Access Compliance Report

Public Rights-of-Way

(Curb Ramps)

Intersection ID: 2852	Main Street: EDINMEADOW_LN	Cross Street: HUNTMEADOW_DR	Location: SE
ADA ID: 8F63A26BDE9C	Ramp Type: BlendTrans1	Initial Pass/Fail: Fail	Overall Compliance: No
Severity Score: 1.25			
Codes/Mitigation Info/Possible Solution		Field Measurements/Component Compliance

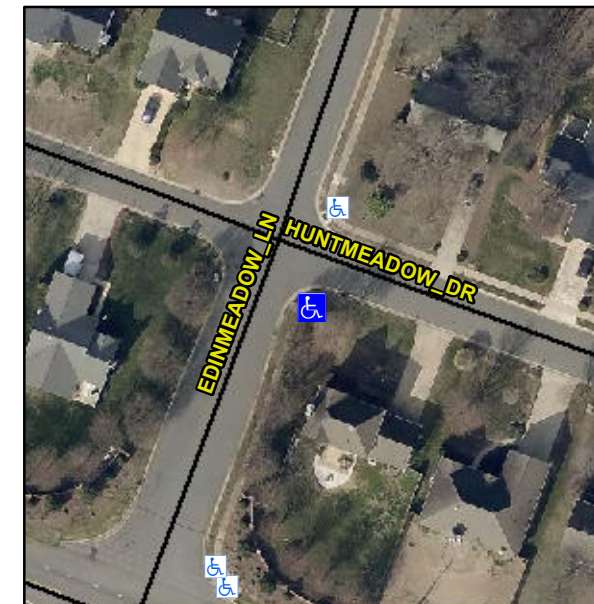
Not Found, R304.5.3

Compliance	Description	Data	Compliance	Description	Data
N/A	Ramp Length (in)	49.5	Yes	BlendTrans Slope (%)	2.8
Yes	Ramp Width (in)	57.0	No	BlendTrans XSlope (%)	3.5
N/A	Flare Type LT	N/A	N/A	Flare Type RT	N/A
N/A	Flare Slope LT (%)	N/A	N/A	Flare Slope RT (%)	N/A
N/A	Flare Traversable LT?	N/A	N/A	Flare Traversable RT?	N/A
N/A	Landing Length (in)	N/A	N/A	DWS Provided?	N/A
N/A	Landing Width (in)	N/A	N/A	DWS Contrast?	N/A
N/A	Landing Slope (%)	N/A	N/A	DWS Length (in)	N/A
N/A	Landing X Slope (%)	N/A	N/A	DWS Full Width?	N/A
N/A	Landing Curb? (Y/N)	N/A	N/A	DWS Offset (in)	N/A
N/A	Shared Landing?	N/A			
N/A	Gutter Ponding?	N/A	N/A	Gutter Slope (%)	N/A
N/A	Gutter Lip Ht (in)	N/A	N/A	Gutter X Slope (%)	N/A
N/A	Painted X Walk1?	No	N/A	Painted X Walk2?	N/A
	X Walk 1 Direction	To NE		X Walk 2 Direction	N/A
	X Walk 1 Width (in)	N/A		X Walk 2 Width (in)	N/A
	X Walk 1 Slope (%)	1.5		X Walk 2 Slope (%)	N/A
	X Walk 1 X Slope (%)	1.3		X Walk 2 X Slope (%)	N/A

N/A	Ramp inside XWalk1?	N/A	N/A	Ramp inside XWalk2?	N/A
	Road Slope (%)	1.3		Clear Space?	N/A
	Road X Slope (%)	1.5	N/A	Clear Space to XWalk (in)	N/A
N/A	Any Obstructions?	N/A	N/A	Storm Grate/Utility Hazard?	N/A
	Obstruction Type			Storm Grate/Utility Type	
		N/A			N/A
			Yes	Surface Condition? (G/P)	Good
			No	Curb Slope (%)	15.7

Remove & Replace Curb Ramp With Two New Directional Ramps or Equivalent.
